### SG503 SWITCH TOLERANCE

PRODUCT MODIFICATION SUMMARY  
SG503

For TEKTRONIX® SG503 Levelled Sine-Wave Generator

FIG. #1 TOP VIEW

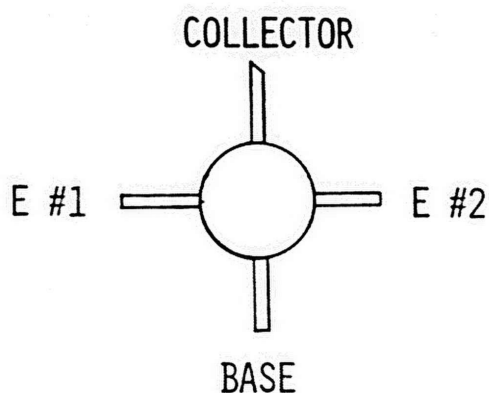
Due to inquiries from the field and lack of documentation of P/N 151-0514-00, I am providing this lead configuration information. Before trimming any of the leads on this device, you should note that the collector lead, Figure 1, has a 45° angular cut. I suggest that you mark the ceramic body of the transistor with a pencil or felt tip pen to indicate the collector. Once the leads are trimmed, your mark will be your guide for the collector.

Fig. 2. PARTIAL ATTENUATOR CIRCUIT BOARD, A3

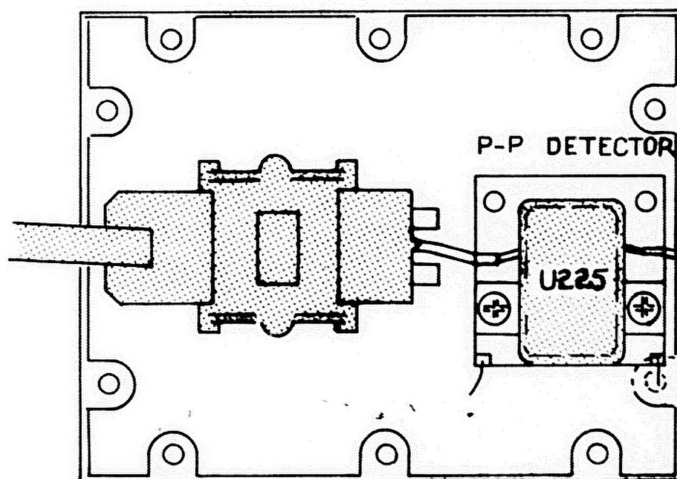
Microcircuit, pn 155-0107-00, and R265-R262, a 100 $\Omega$  potentiometer and a 100 $\Omega$  resistor connected in series, are required to replace U225. R265, the .5V P-P Amplitude Set potentiometer, is changed to 100 $\Omega$  to accommodate for variations in characteristics of U225.

- ( ) 7. Replace U225 with the microcircuit from the kit as follows:
  - a) Put the AMPLITUDE MULTIPLIER Switch in the X.01 position.
  - b) Remove the two mounting screws.
  - c) Unsolder the two gold leads from the circuit board, the two bare wires from U225, and remove U225.
  - d) Mount the new microcircuit from the kit, using the screws removed above, solder in place and solder the two bare wires to U225.
  - e) Reinstall Attenuator cover.

DIAGRAM 2 AUTO-RANGING COUNTER - Partial

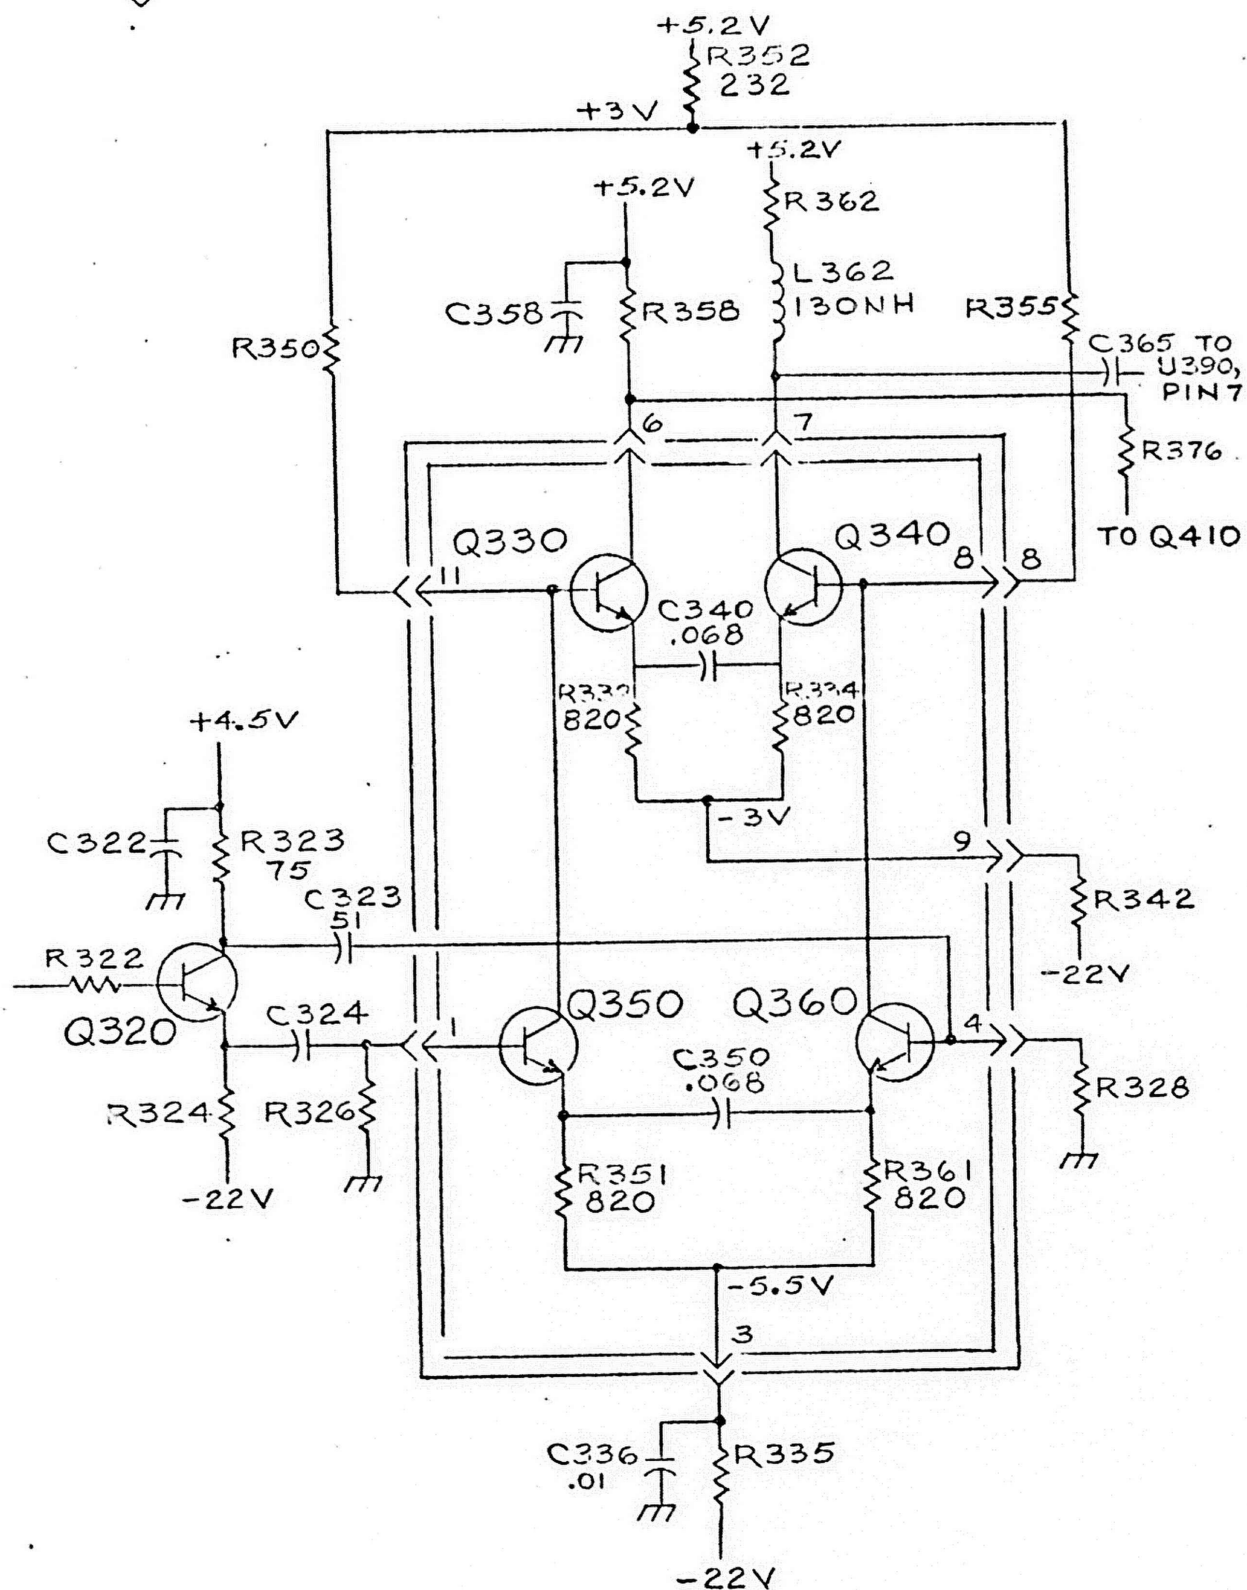
IC replacement circuit board PN 670-5045-00 and several component changes are necessary to replace U350 to assure correct LED readout at high ambient temperatures.

C323*	283-0299-00	51pF 500V 5%
C328	Delete	
C335	Delete	
C336	283-0204-00	.01 $\mu$ F 50V 20%
C340*	283-0249-00	.068 $\mu$ F 50V 10%
C342	Delete	
C345	Delete	
C350*	283-0249-00	.068 $\mu$ F 50V 10%
C360	Delete

R323	315-0750-00	75 $\Omega$ 1/4W 5%
R332*	317-0821-00	820 $\Omega$ 1/8W 5%
R334*	317-0821-00	820 $\Omega$ 1/8W 5%
R338	Delete	
R340	Delete	
R345	Delete	
R351*	317-0821-00	820 $\mu$ 1/8W 5%
R352	321-0132-00	232 $\Omega$ 1/8W 1%
R360	Delete	
R361*	317-0821-00	820 $\mu$ 1/8W 5%

U350	Delete
------	--------

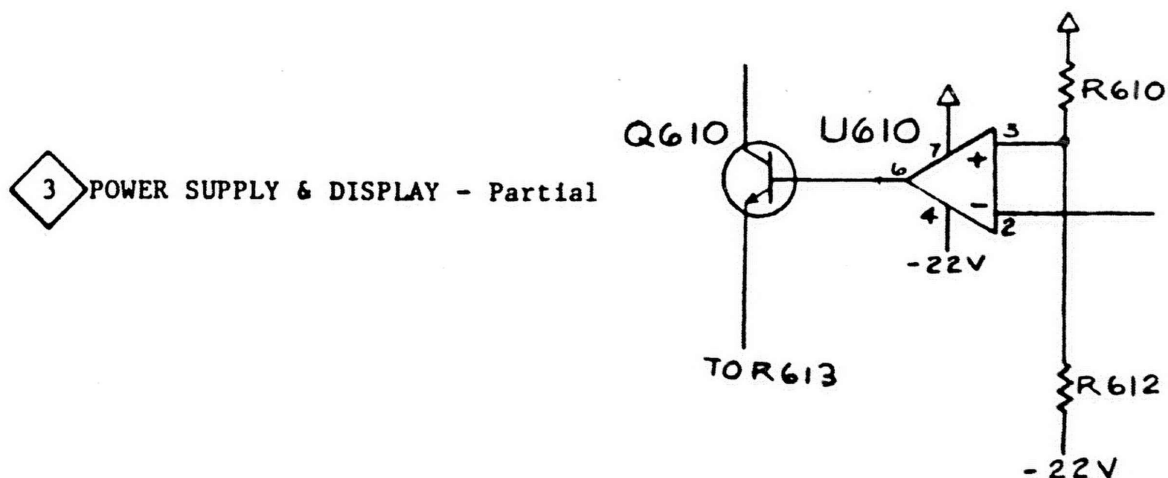
Integrated circuit part number 156-C067-00 and a 2.4k $\Omega$  resistor are required to replace U610. At the same time VR610, C610 - R611, a .01 $\mu$ F capacitor and a 5.6k $\Omega$  resistor, connected in series between pins 2 and 6 of U610 are removed.

Ckt. No.	Part Number	Description
C610	DELETE	
R611	DELETE	
R613	315-0242-00	Resistor, cmpsn, 2.4k $\Omega$ 5% .250W
VR610	DELETE

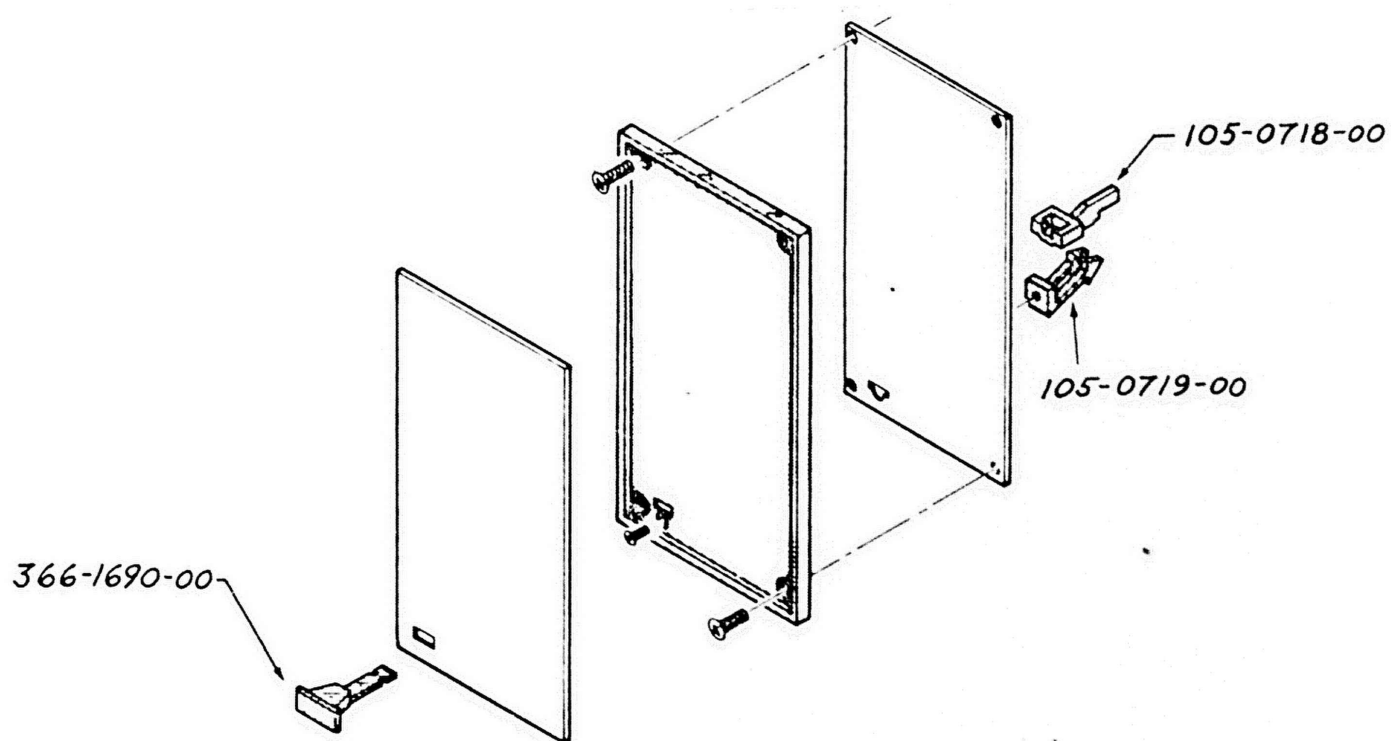
214-1513-01	Latch, plug-in retaining
214-1840-00	Pin, knob securing
366-1422-01	Knob, latch

105-0718-00	Bar, latch release
105-0719-00	Latch, plug-in retaining
366-1690-00	Knob, latch

PLUG-IN LATCH ASSEMBLY DETAIL

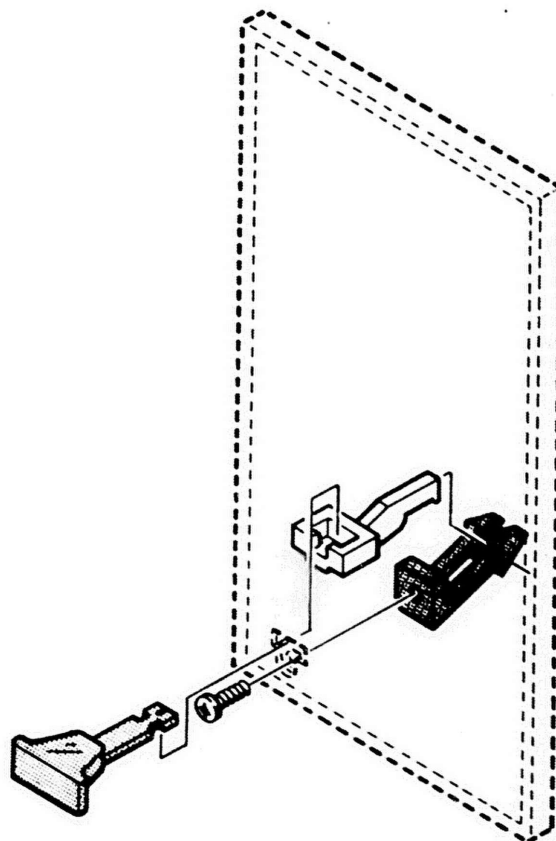
This Parts Replacement Kit contains parts to replace the Plug-in Latch with a new improved type.

- ( ) 7. Refer to the drawing and install the latch release and the Plug-in latch knob.
- ( ) For future reference, correct the Mechanical Parts List in your Instruction Manual.

## PLUG-IN SUPPORT IMPROVED

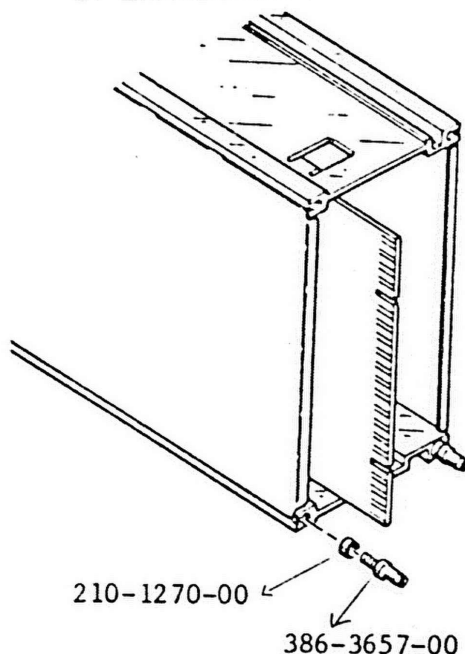
To improve the support of plug-ins at the interface connector in TM515 Portable Power Modules, two support pins and two washers were added to the bottom frame rail.

FIG. 1 - PARTIAL MAIN CIRCUIT BOARD (FRONT)

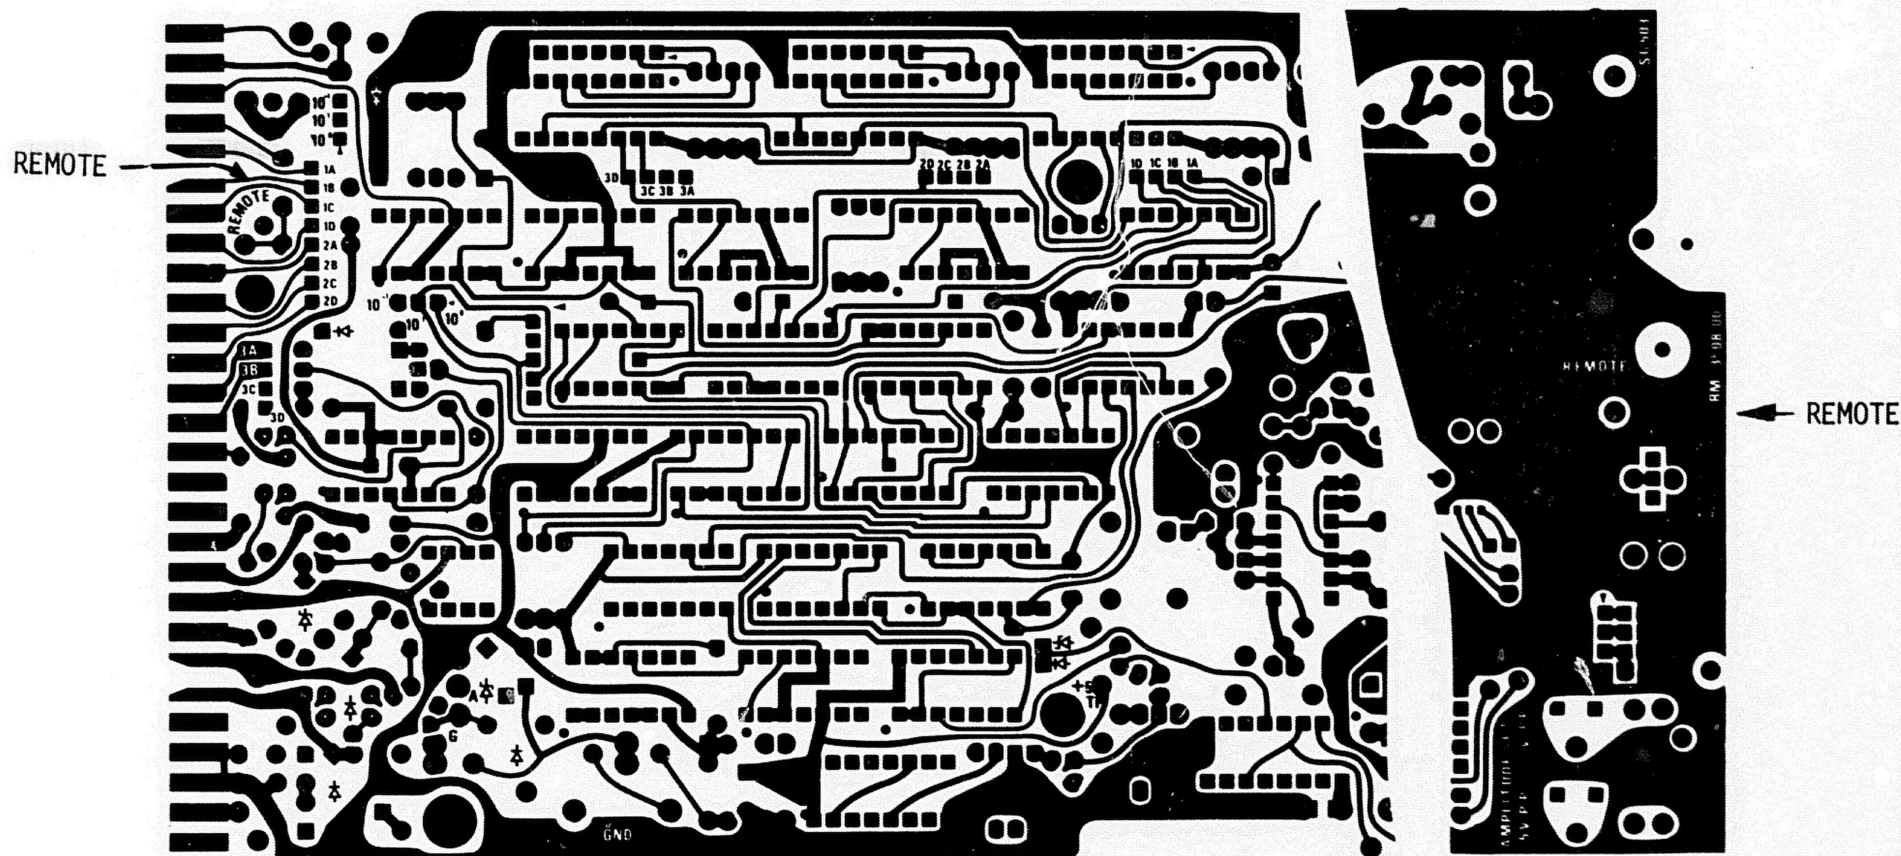
- 1) To convert the OUTPUT AMPLITUDE Control from a front panel control to a remote DC level operated control which is addressable thru the rear connector. The Constant Amplitude Sinewave Output voltage can be varied from .5V (with AMPLITUDE MULTIPLIER in the X1 position) to 5.5V p-p by changing the externally applied DC voltage from -1 volt to -11 volts.
- 2) To provide BCD and Decimal outputs at the rear connector.
- 3) If the SG503 is to be used as an uncalibrated signal source ONLY, the Sinewave Output can be rerouted to go through the rear connector.

Add ribbon wires to the front of the Main circuit board as follows:
